**Department of Energy**

**BASALT WASTE ISOLATION PROJECT (BWIP) RESOLUTION OF NUCLEAR REGULATORY COMMISSION (NRC) COMMENTS ON PRE-EXPLORATORY SHAFT (ES) GEOHYDROLOGY TESTING PROGRAM**

On August 31, 1987, the NRC provided comments on the referenced BWIP documents. The DOE response to the NRC comments is provided for your information. We trust that this information will assist you in your review of these activities.

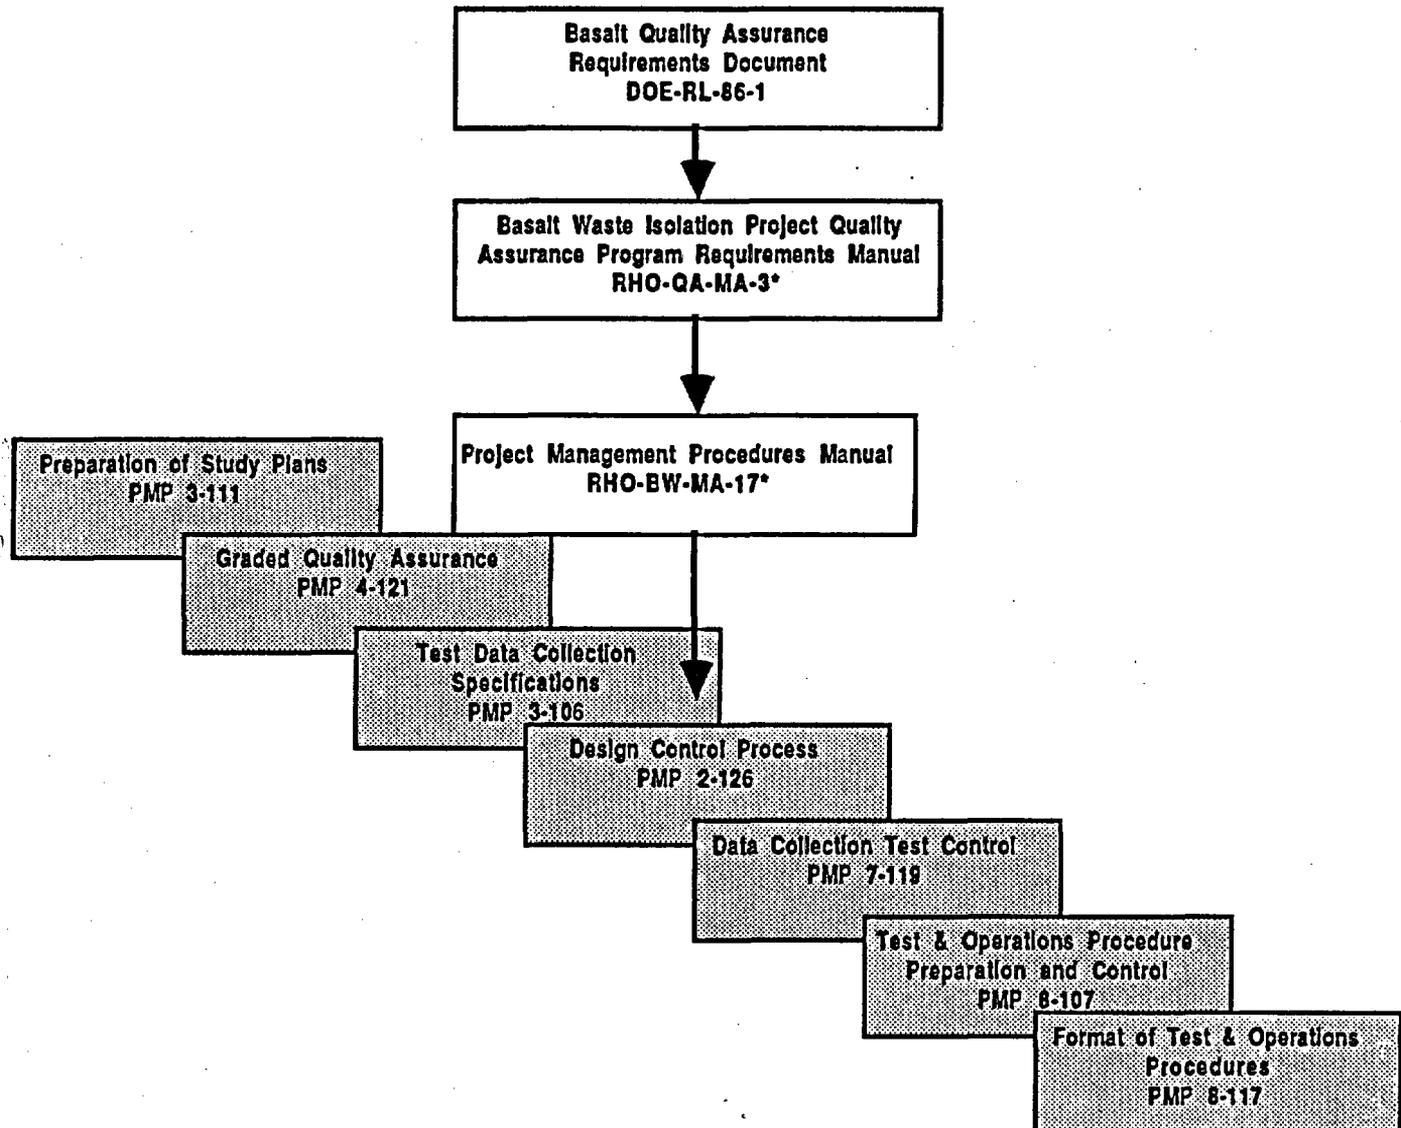
- a. ***According to the section on "PURPOSE" in FI-DC-241, it is the procedure which controls the drilling of DC-24CX, however it does not reference HS-BC-0001, the "specification for borehole drilling/construction, CX piezometer facilities". FI-DC-241 is a very general document which leaves in question exactly what is expected, whereas HS-BC-0001 contains very specific requirements which are sometimes stated differently. For example, 6.2.1.1 of FI-DC-241 requires that "Maximum allowable change in deviation between two consecutive measurements is 1 degree and no more than 5 degrees total deviation at any point in the borehole" while 3.2.2.3 of HS-BC-0001 requires that "Indicated Inclination for any single measurement shall not exceed 5 degrees from vertical, and the change in indicated inclination between two consecutive measurements shall not exceed 1 degree. In addition, the completed borehole shall be such that the absolute deviation from the hole centerline of the surface entry point of the hole centerline of any other measurement point (8.1) in the hole does not exceed 5 degrees from the vertical". Which document is the controlling document for the drilling operations and exactly what specification will be the controlling specification?***

The Integrating TOP (FI-DC-241) "Purpose" section references the Test Plan (SD-BWI-TP-045). The Test Plan references the Specifications for Piezometer Facilities (HS-BC-0001 through HS-BC-0008 and Drawings H-6-4300 through H-6-4310).

The borehole deviation requirements, as stated in the different documents, convey equivalent information. The wording varies slightly because the documents were prepared by different authors with different technical expertise and writing styles. Documented technical reviews of these documents by qualified reviewers assure consistent interpretation of the requirements. In the future we will attempt to utilize identical nomenclature within test documentation.

A Detailed Hierarchy of Documents for the Drilling of DC-24CX, DC-25CX, DC-32CX, and DC-33CX is shown on page 4. The Integrating TOP (FI-DC-241) and subordinate TOPs are used for control of drilling of the borehole.
